Long Road Racing

Global MX-5 Cup Car Technical Service Bulletin #03-01-2018 sections A & B

- A) Front bumper beam and 'form fitting' foam fill
- B) Shorter tow straps mounts

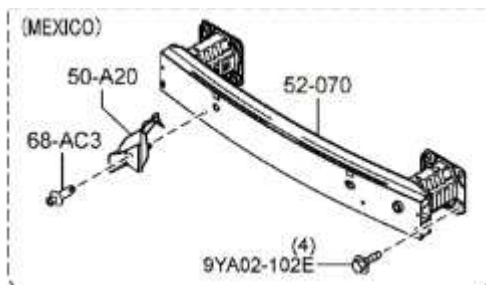
1. The original US spec front bumper beam may be replaced using the Mexico spec beam (Mazda part number N243-50-070D) and Japan spec foam insert (Mazda part number N243-50-111). These two parts must be used together as an "assembly". The foam insert is molded to better conform to the inner surface of the front fascia and may reduce fascia damage during bump drafting.
2. **NOTE: The air guide (see diagram below 50-A20) is required only if this TSB is NOT used**
